July 30, 2010
Project No. 401426002

Subject: Update to Geotechnical Evaluation Report
Student Services and Administration Building
Las Positas College
Livermore, California

Ninyo & Moore		ACCELERATION RESPONSE SPECTRA	FIGURE 7
PROJECT	DATE	STUDENT ADMINISTRATIVE SERVICES BUILDING	
401426002	7/10	LAS POSITAS COLLEGE LIVERMORE, CALIFORNIA

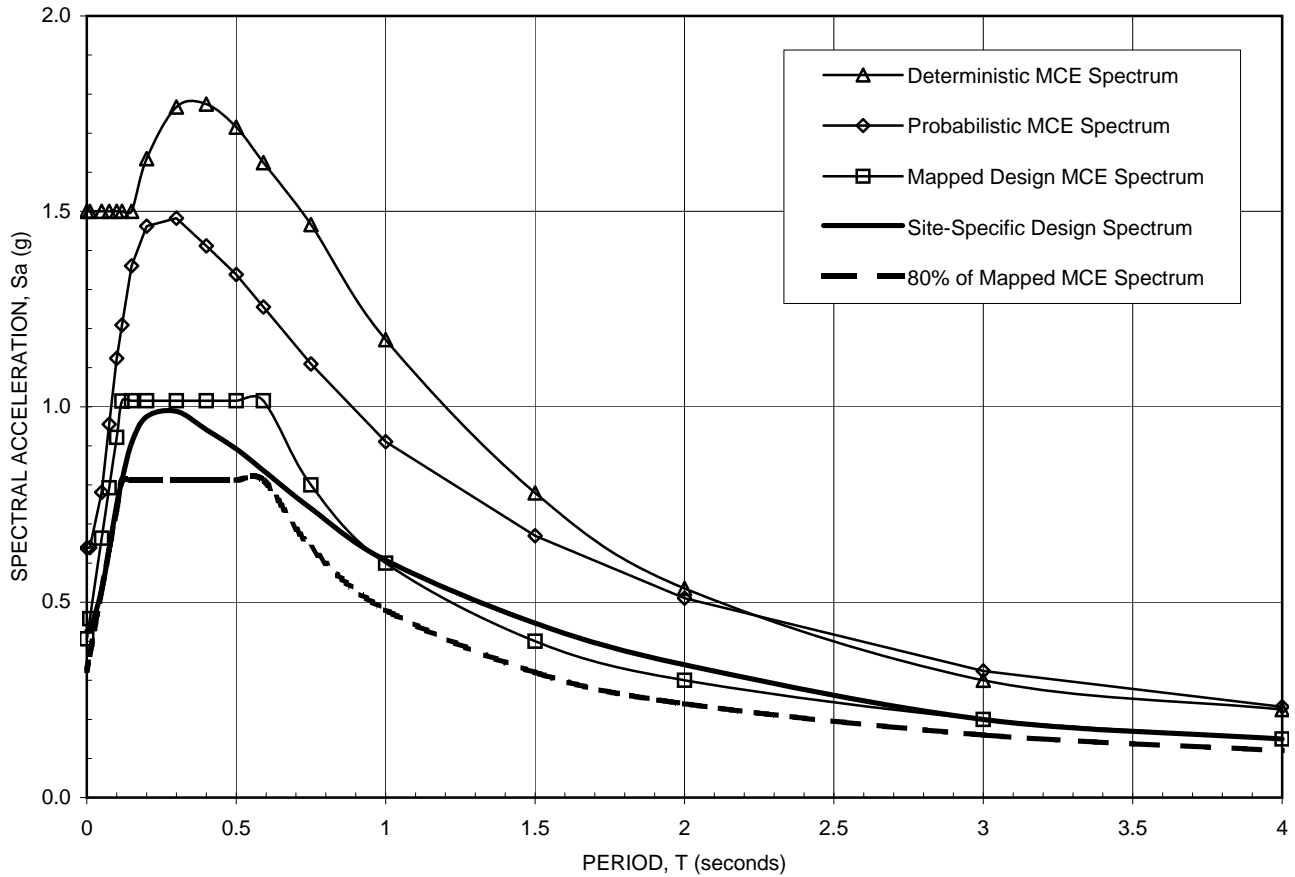
Our review indicates that the referenced geotechnical evaluation report is in substantial compliance with the requirements of 2010 CBC except for the site-specific acceleration response spectra (Figure 7 of the referenced report). The response spectra presented on Figure 7 were based on the guidelines of 2007 CBC and American Society for Civil Engineers (ASCE) Standard 7-05 (2006). The attenuation relations used to develop the deterministic and probabilistic spectra were Abrahamson and Silva (1997), Sadigh et al. (1997) and Campbell (1997). The 2010 CBC, however, requires that the Next Generation Attenuation (NGA) relations be used while evaluating site-specific ground motion. Accordingly, we have revised the site-specific response spectra. The NGA relations we used for developing the deterministic and probabilistic spectra are by Chiou and Youngs (2008), Campbell and Bozorgnia (2008) and Boore and Atkinson (2008). The probabilistic seismic hazard analysis (PSHA) performed using the NGA relations considered the maximum rotated component of the ground motion. The deterministic seismic hazard analysis (DSHA) performed using the NGA relations incorporated the 84th percentile of the maximum rotated component of ground motion. The revised site-

specific acceleration response spectra are attached (Figure 7). These response spectra should supersede the ones presented in our referenced geotechnical evaluation report. As indicated above, the referenced report should be considered in compliance with 2010 CBC upon incorporation of the attached site-specific response spectra.
